Technical Service Bulletin: tsb100609

Released Date: 05-Dec-2007

New Gear Housing

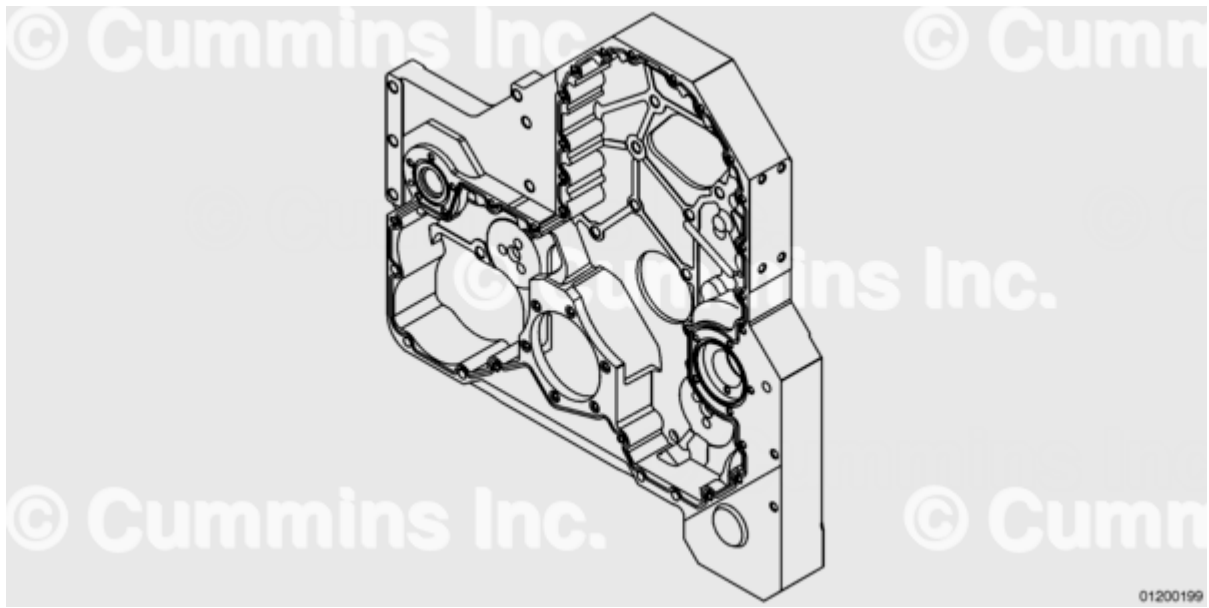
The new gear housing contains a radius in the accessory drive support web area to eliminate the stress riser and eliminate cracking of the accessory drive web support.
